Interactive comment on “Observed variability and trends in extreme rainfall indices and Peaks-Over-Threshold series” by H. Saidi et al.

Answer to Referee #1:

Fig. 1. Study area and spatial distribution of the stations

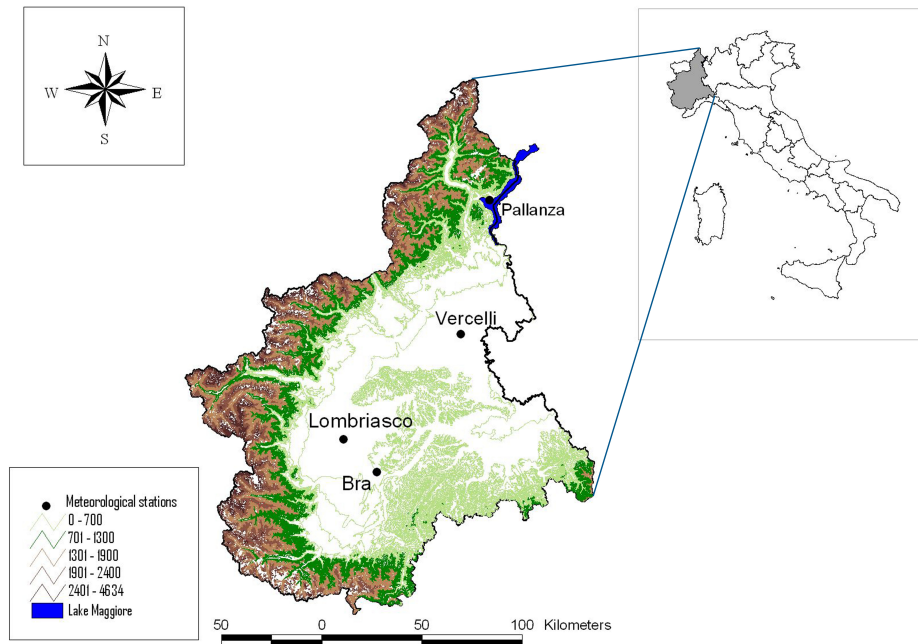
2. A map would be needed to indicate the location of stations relative to orographic barriers and how closely sites are located to each other. (It would also be helpful to provide the location of sites in Table 1 in terms of latitude and longitude.) Is the rainfall regime at these locations similar (i.e. could they be assessed jointly) or rather different (i.e. is there potential for different meaningful trends)?

We agree in general with the reviewers comment that a map is important to indicate the location of the four stations. Figure 1 will be added to the revised version. As suggested by the reviewer the location of the sites in table 1 (supplement file) will be in terms of latitude N and longitude E:

Fig. 2. Percentage differences between magnitudes for 10 year sliding windows and the long term average

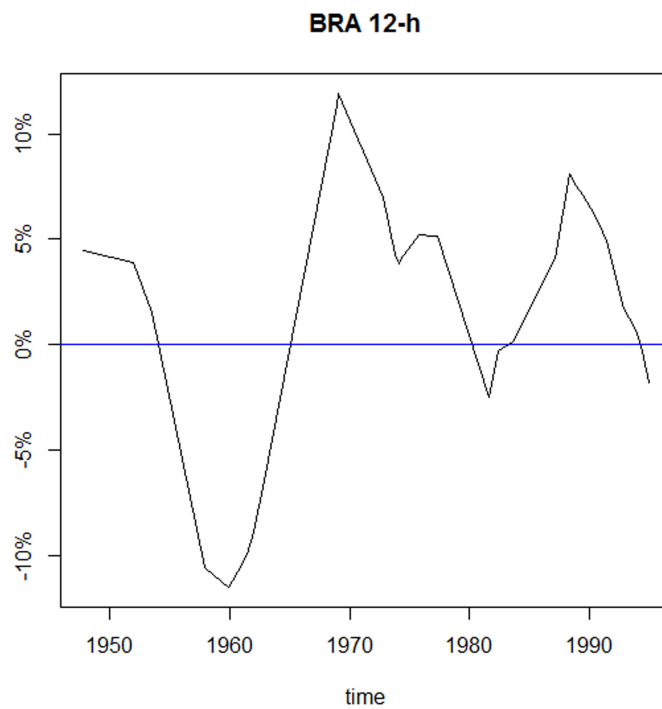
6. How do the authors explain the fact that there is a significant increase in the 12-h annual maxima at Bra (Fig 2) but judging by Figure 11 quantile estimates (based on GPD) are lower for the later than for the earlier period?

“Figure 2” in the manuscript shows significant increase in the 12h annual maxima at Bra and “figure 11” shows that POT series are lower for the later than the Earlier Period. To explain this we have to interpret figure 2 (below). This figure is presenting the percentage difference between magnitudes for 10 year sliding windows and the long term average. The extreme events were reduced for a period around 1950 and 1960. After that period the magnitude of these events has increased. In addition, magnitudes for the 1970s and 1990s are judged higher than the long term average. The later period 1990s and early 2000s the magnitude of events appears to have increased but not similar to the previous period (1970s, more than 10%) Maybe this can justify the fact that the application of trend test (Mann Kendall) shows a significance increase while POT series shows that quantile estimates are lower for the later (1984-2003) than the earlier period. We can clarify it in a revised version.

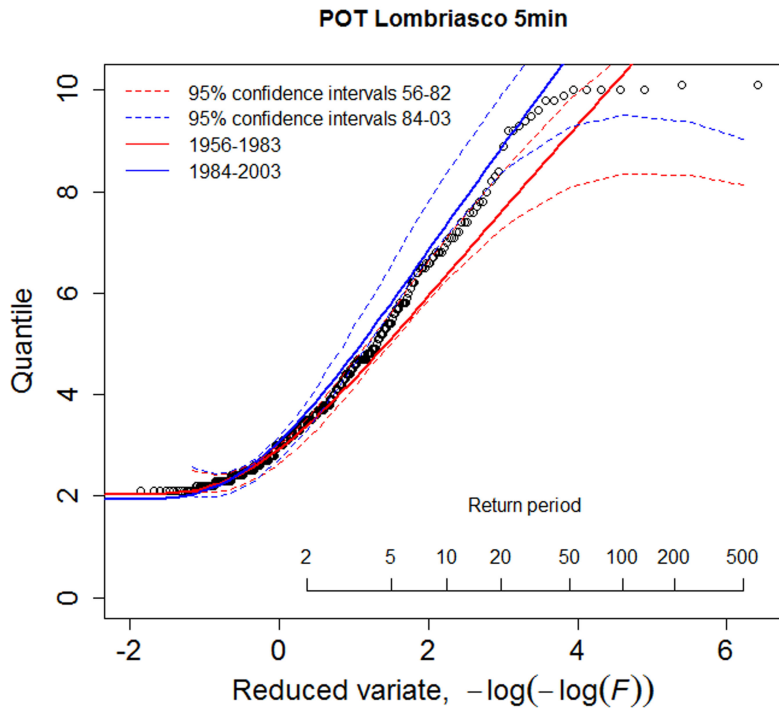
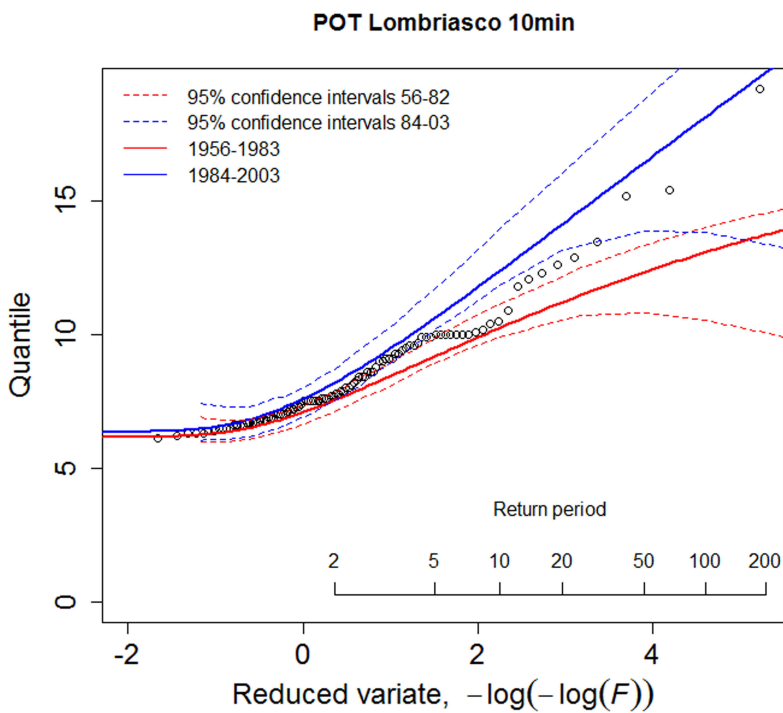
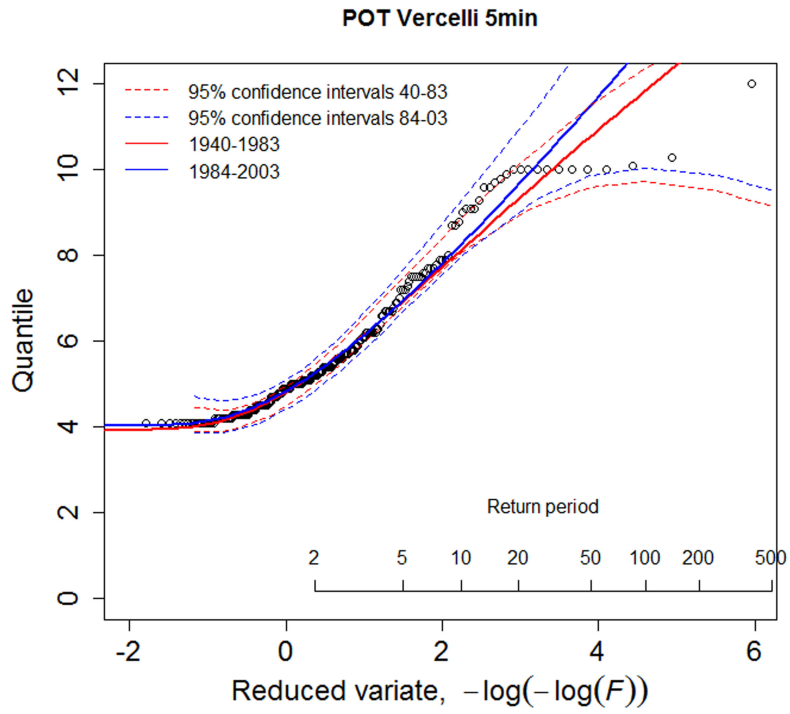
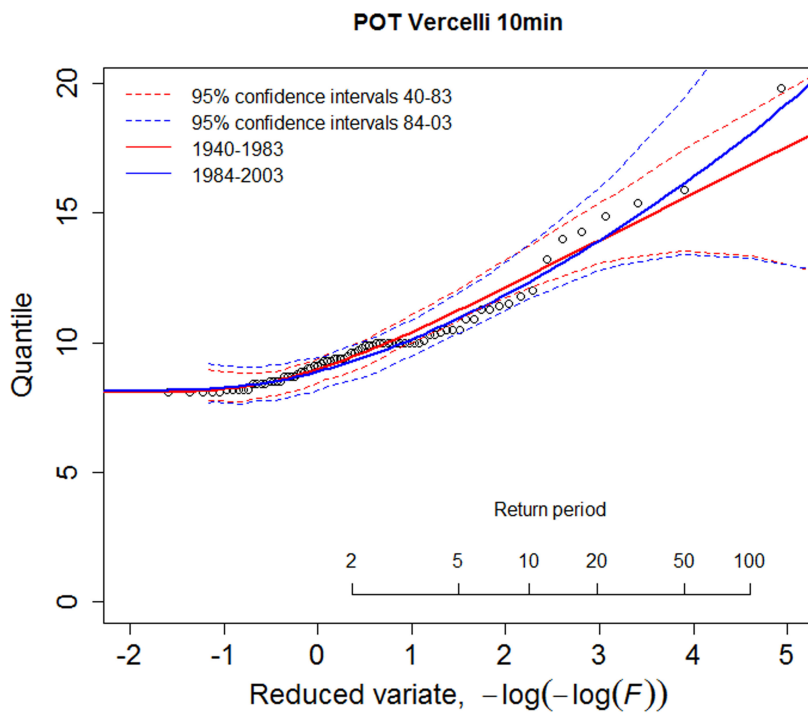
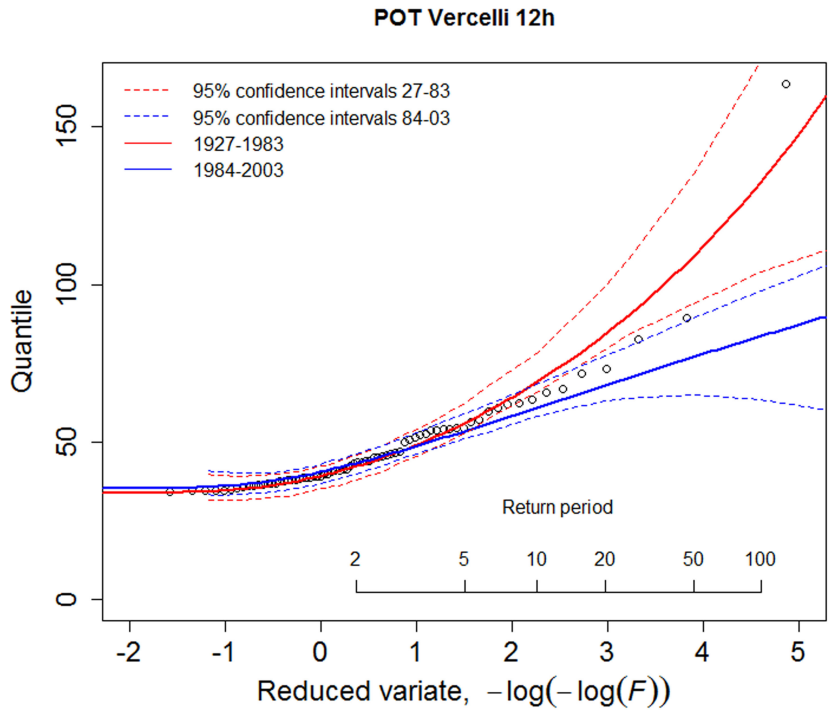
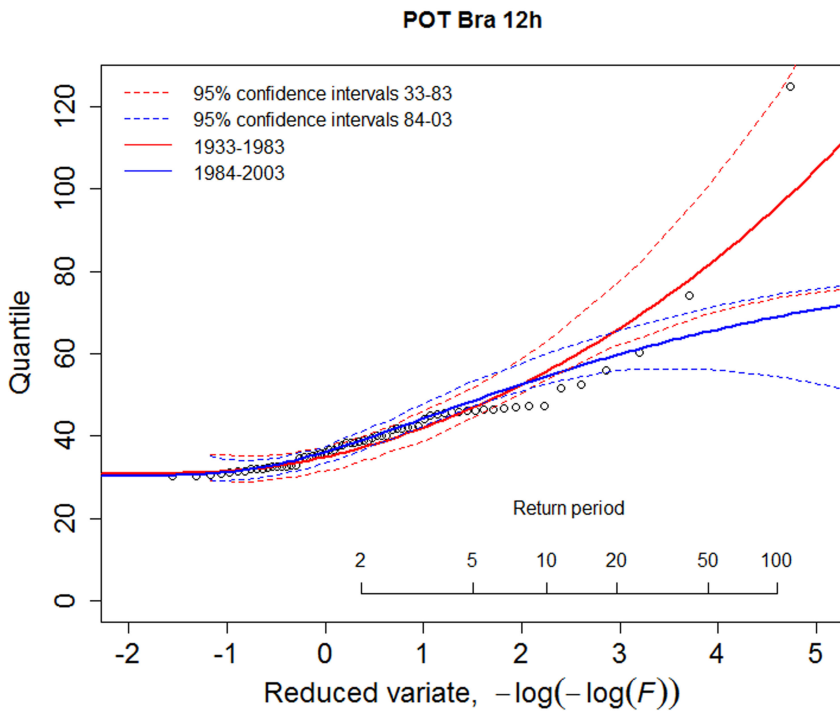
8. No attempt has been made to assess the significance of changes in quantile estimates from the earlier to the later period (for instance by constructing confidence intervals). What is referred to as ‘growth curves’ are in fact ‘frequency curves’ (Figure 9 onwards).

We agree with the reviewer comment that what is referred to as “growth curves” are in fact “frequency curves”. In fact, for our statistical analysis we prepared two graphs (growth and frequency curves) and only frequency one were used in this manuscript. We estimate the lower and upper limits of a specified confidence interval using Bootstrap method. Frequency curves with 95% confidence intervals are shown in figures 3-4-5-6-7-8. We will insert this figures in a revised version of the manuscript.
